ADDENDUM
NO. 2

October 31, 2023

HANOVER COMMUNITY SCHOOLS - JANE BALL ELEMENTARY RENOVATIONS AND HIGH SCHOOL IMPROVEMENTS

GYMNASIUM COURT MARKING PLAN (1 / A-840)
SCALE: 1/4" = 1'-0"

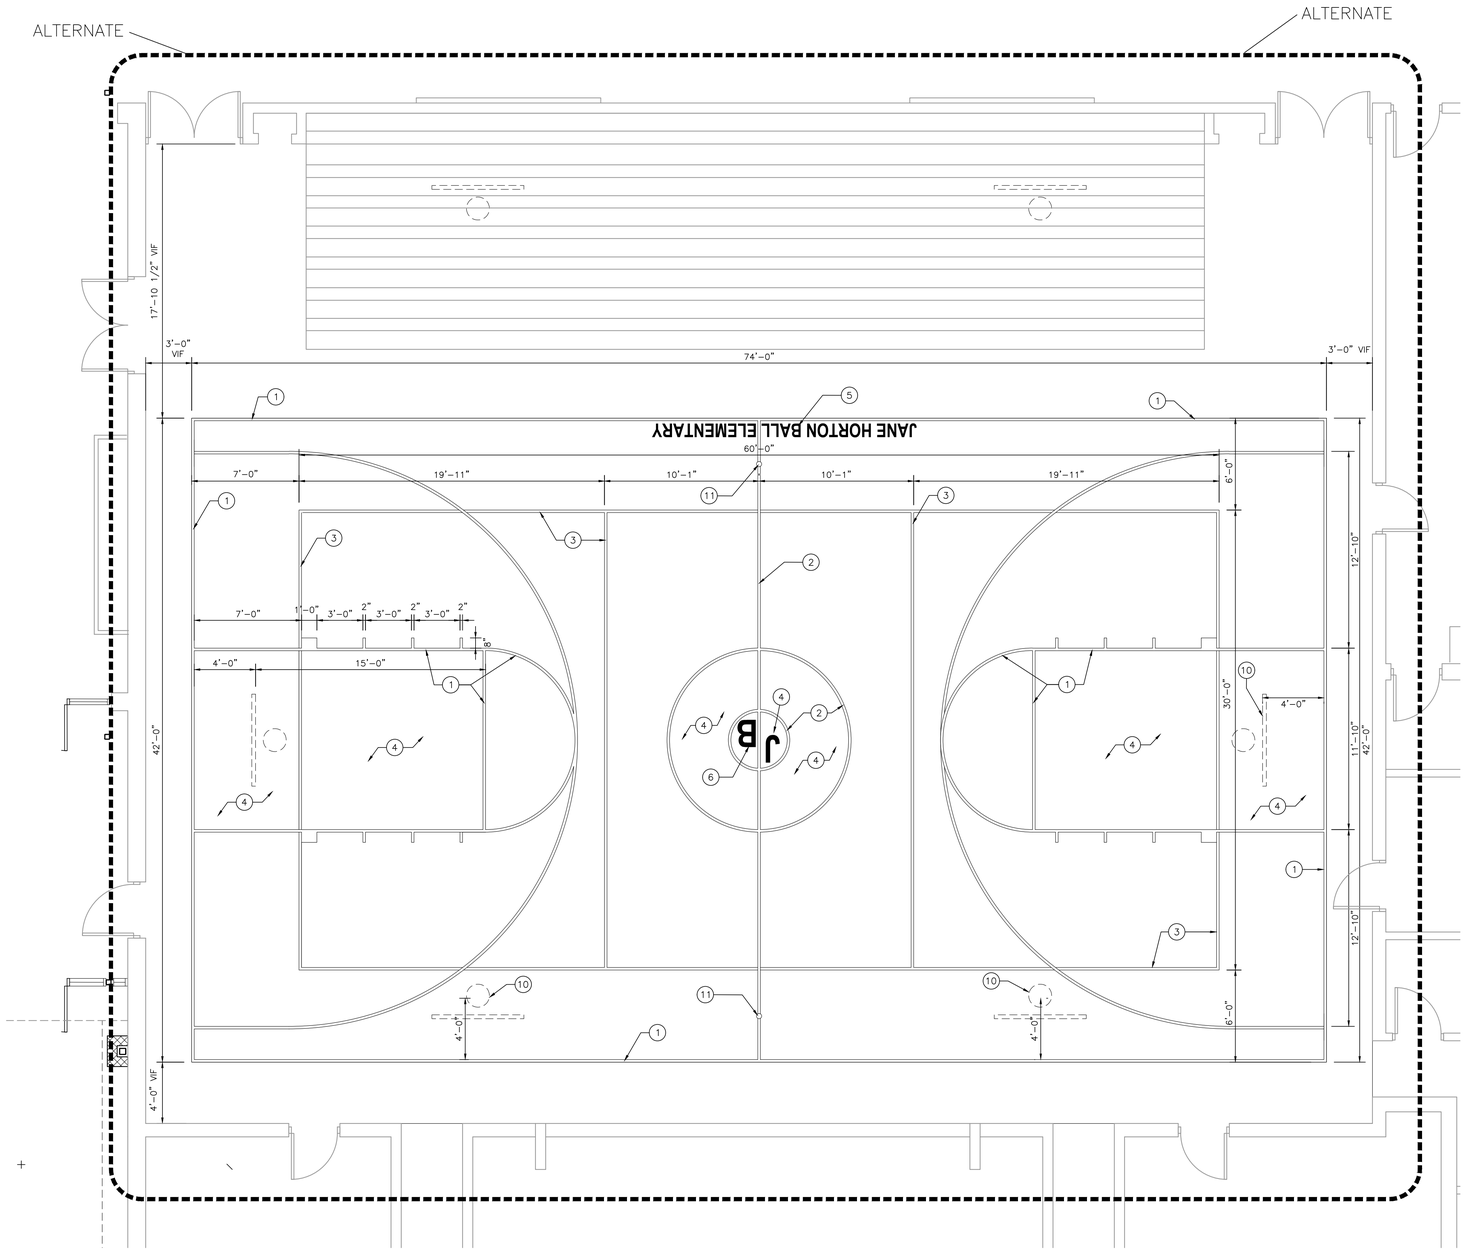
A. Refer to added full size drawing, included in this Addendum, for gym floor striping.

SHEET MD102

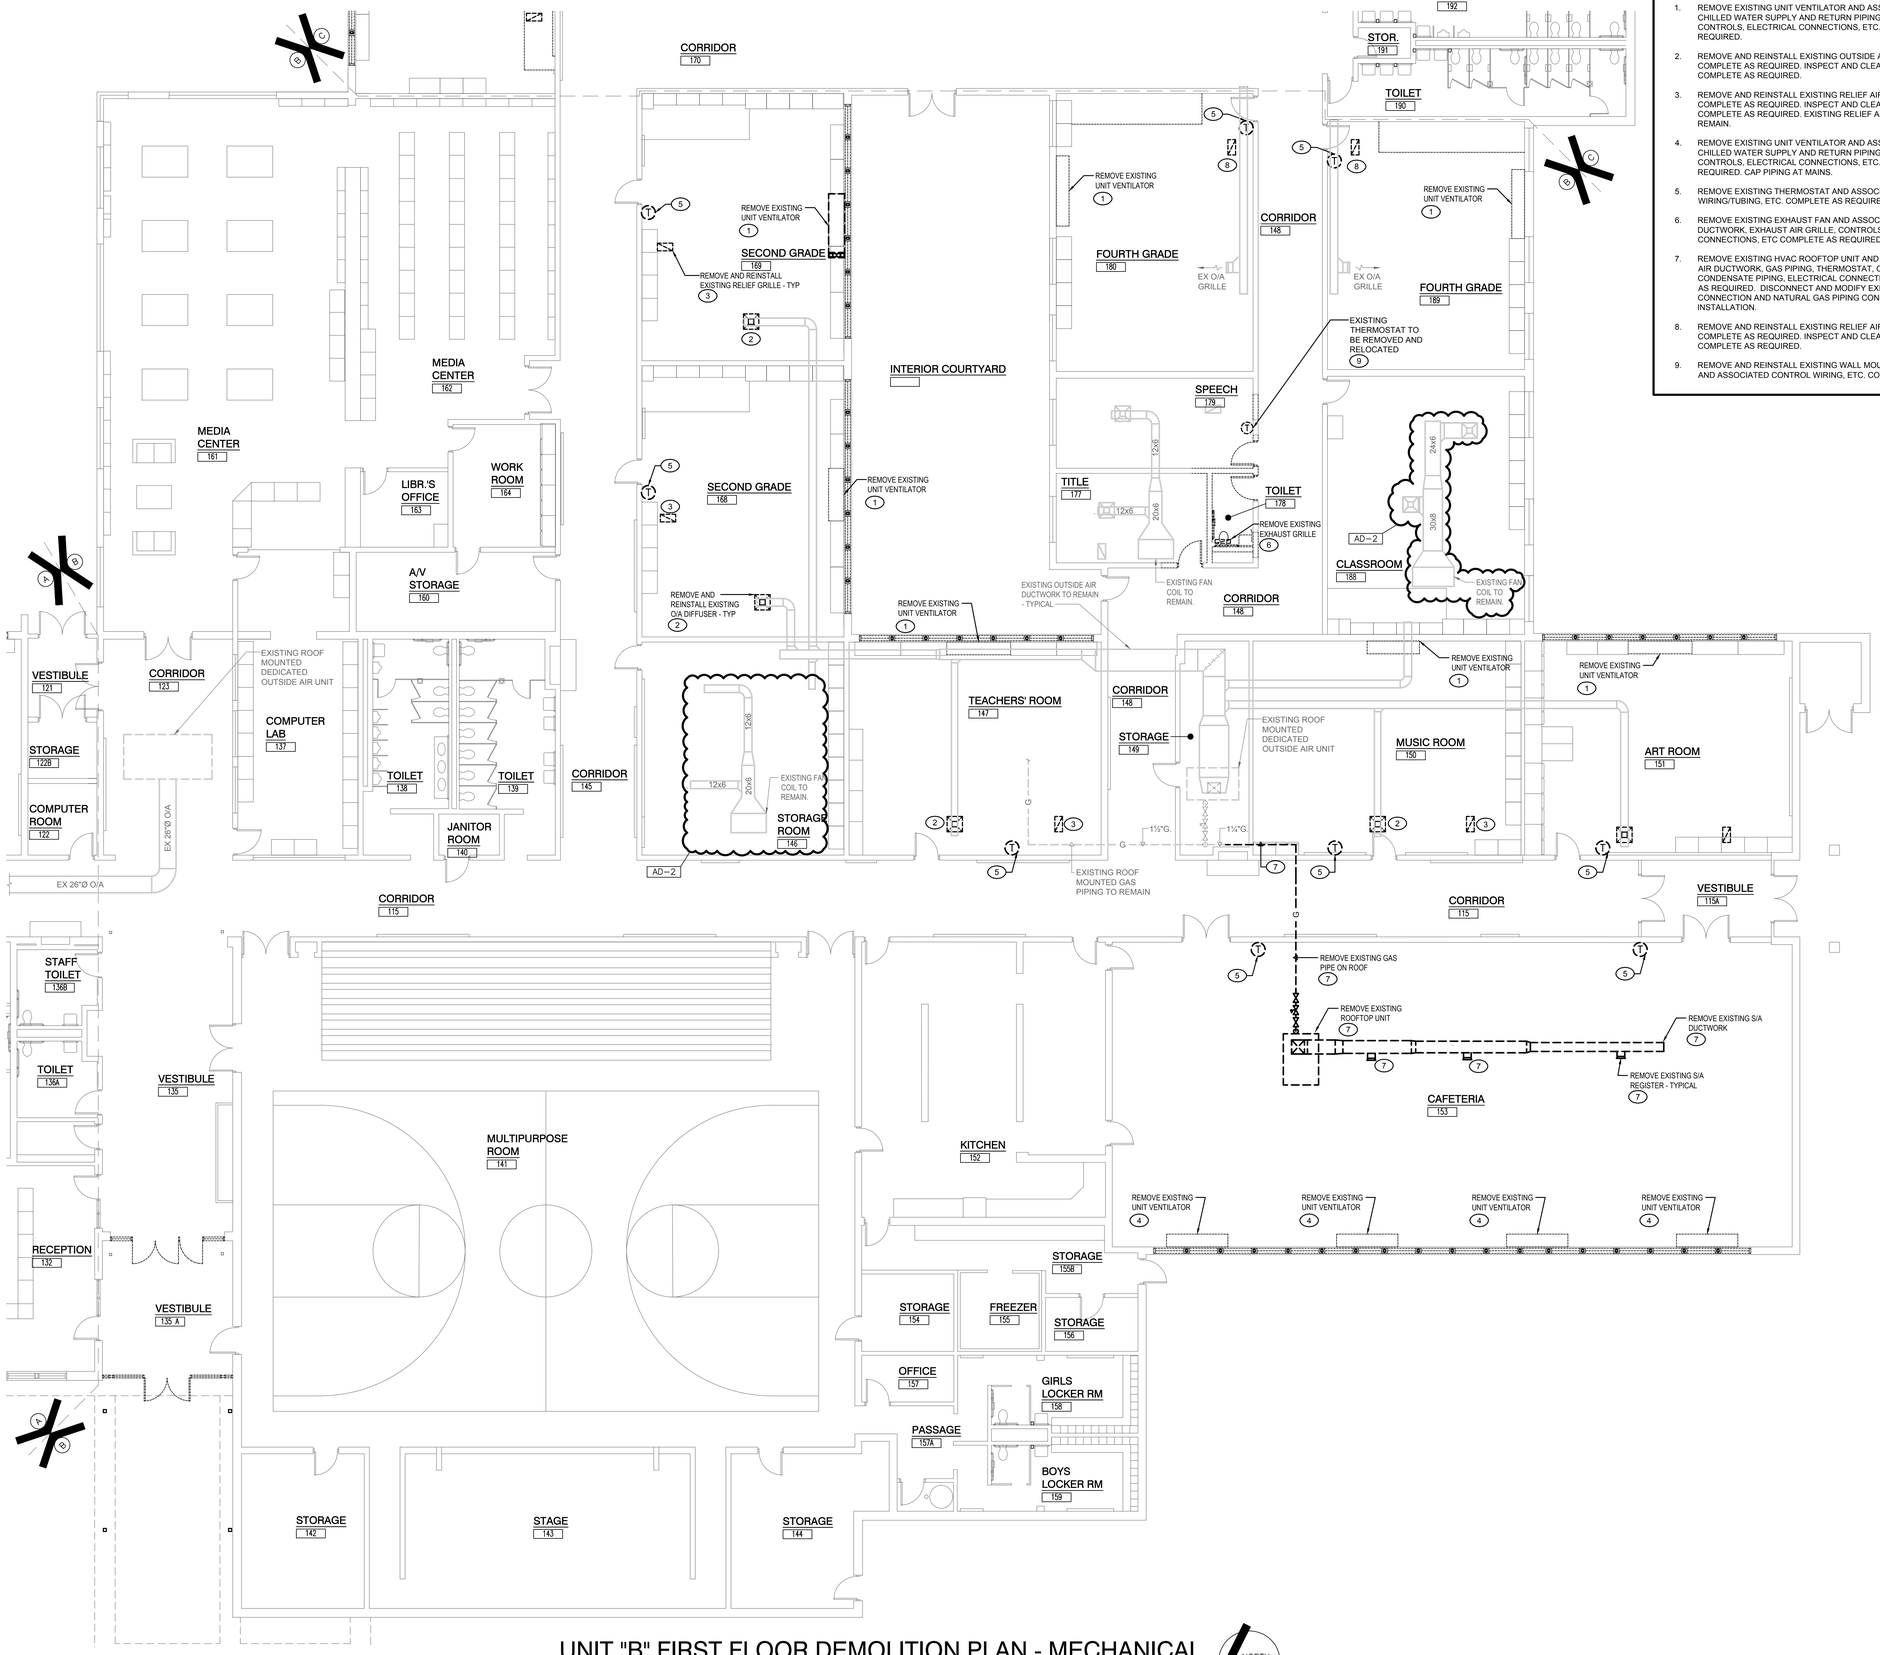
A. Refer to added existing air handler units and ductwork.

SHEET MD103

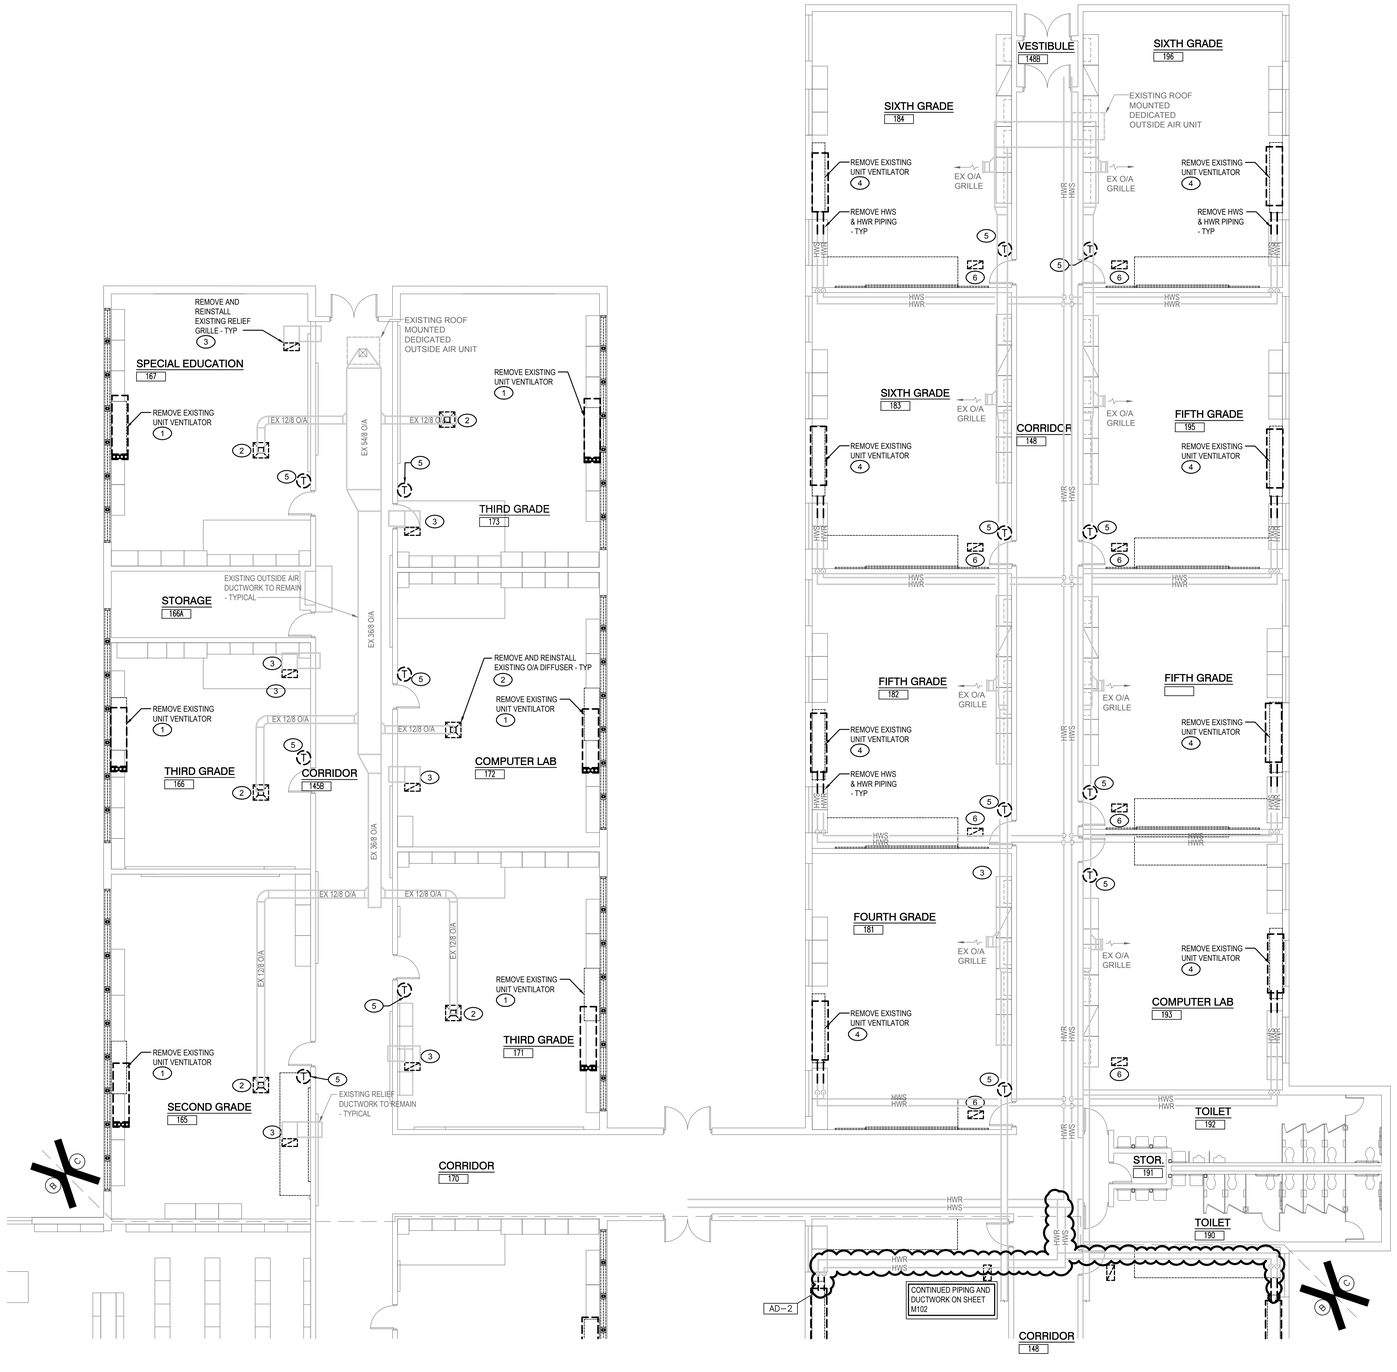
A. Refer to added existing hot water supply and return piping.

SHEET M-102

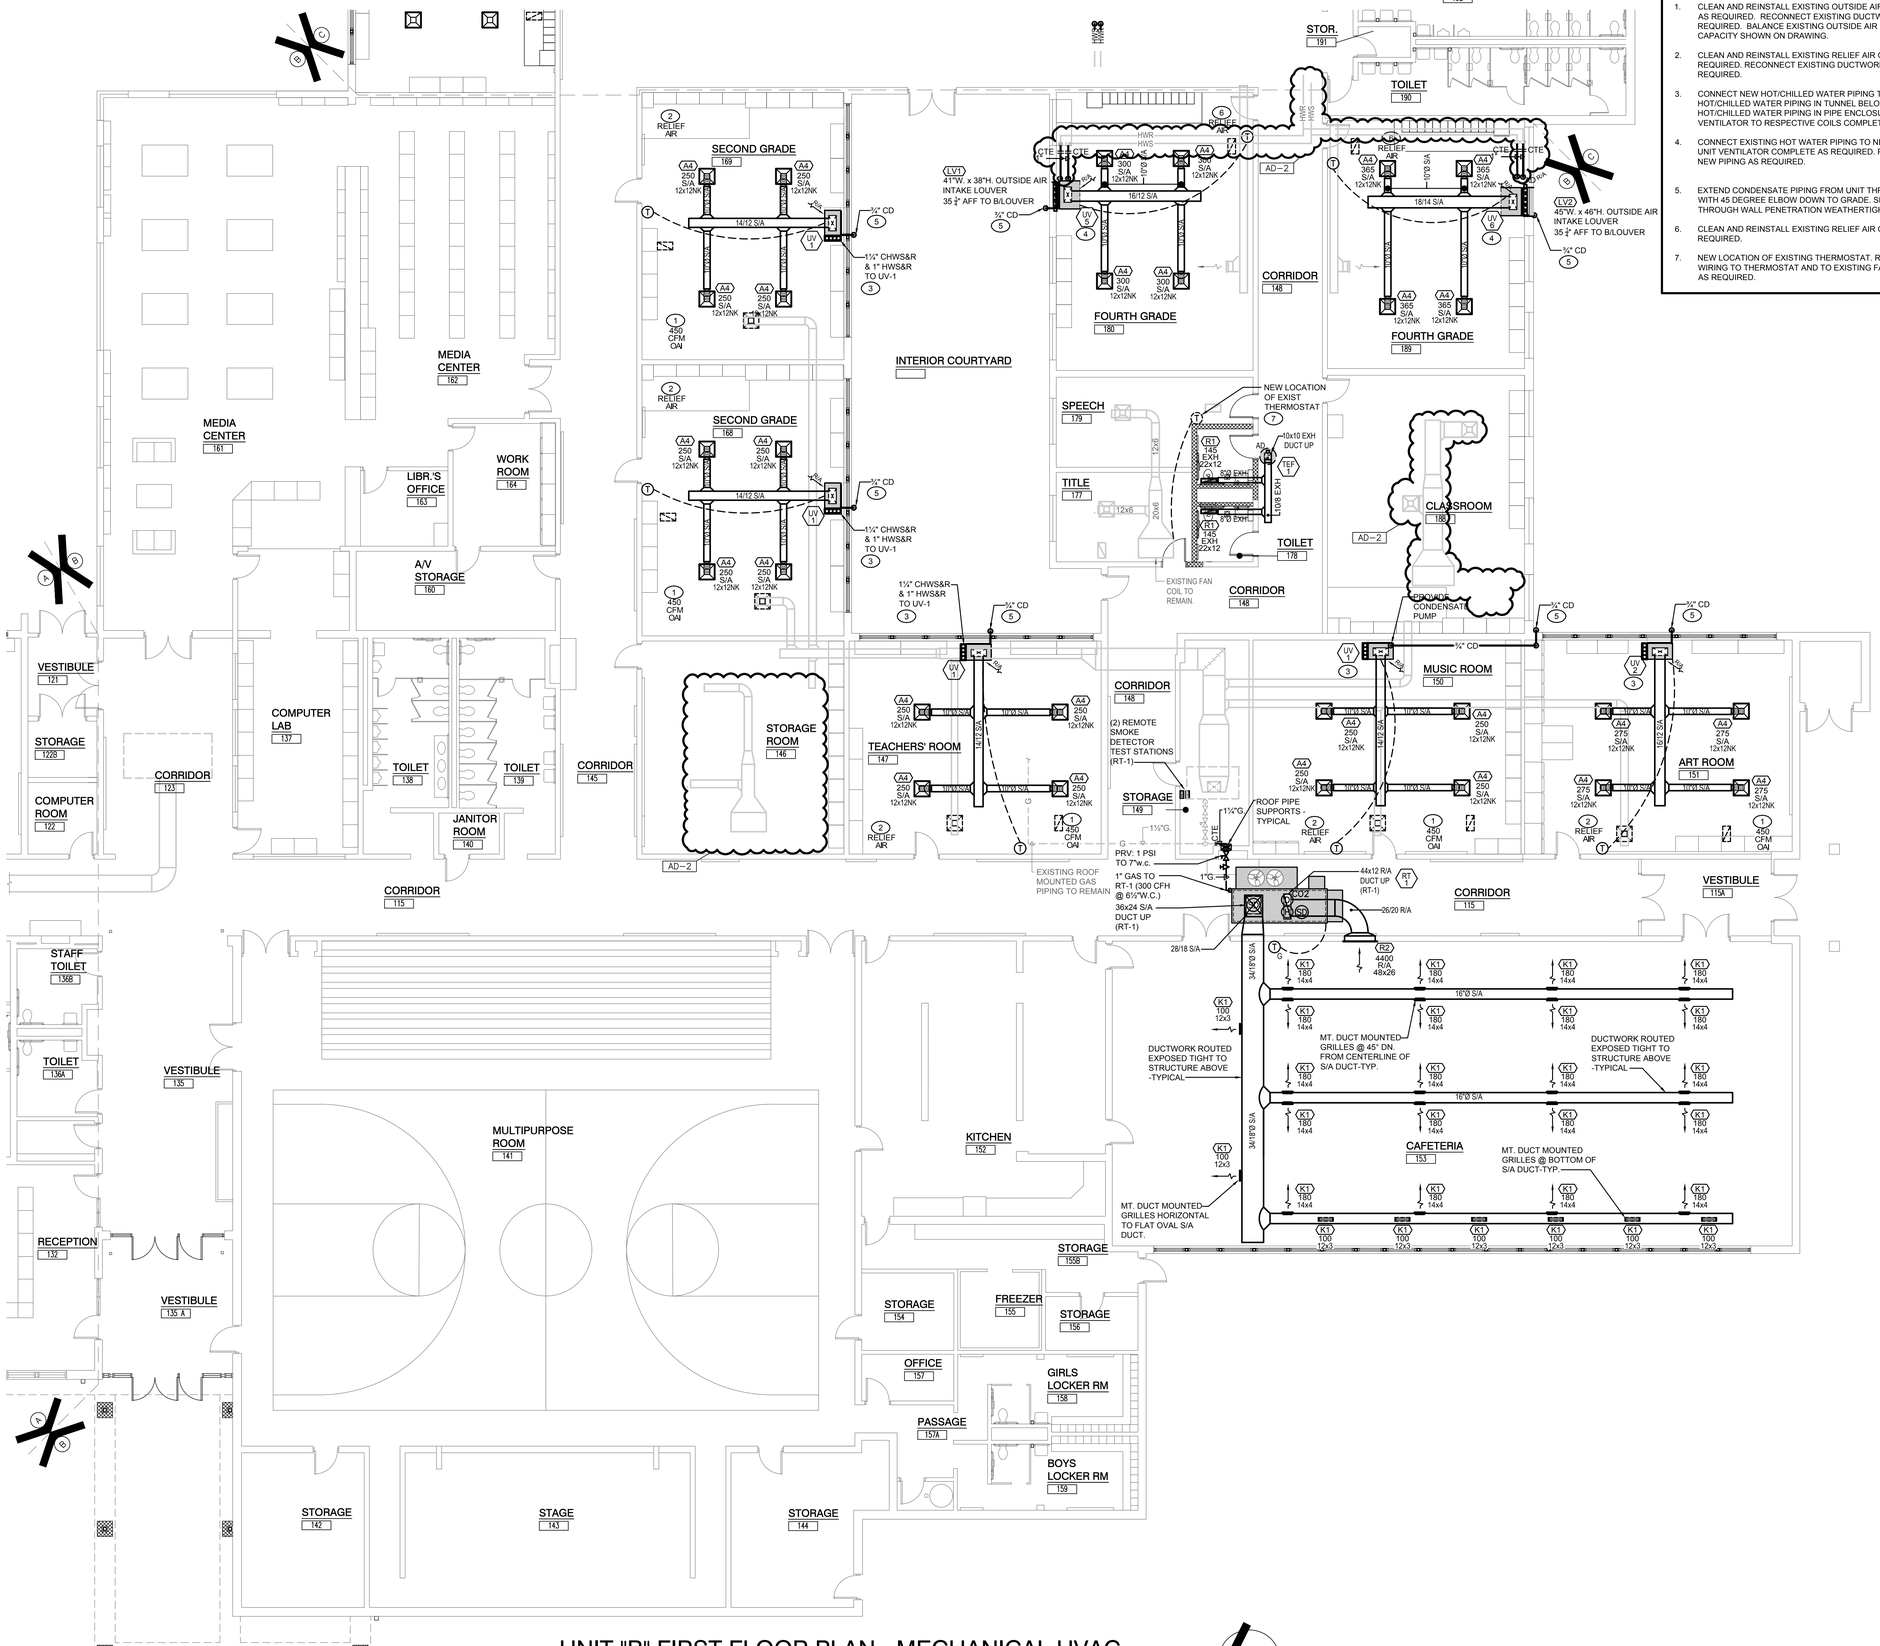
A. Add existing piping.

B. Revise new piping.

C. Add existing ductwork.
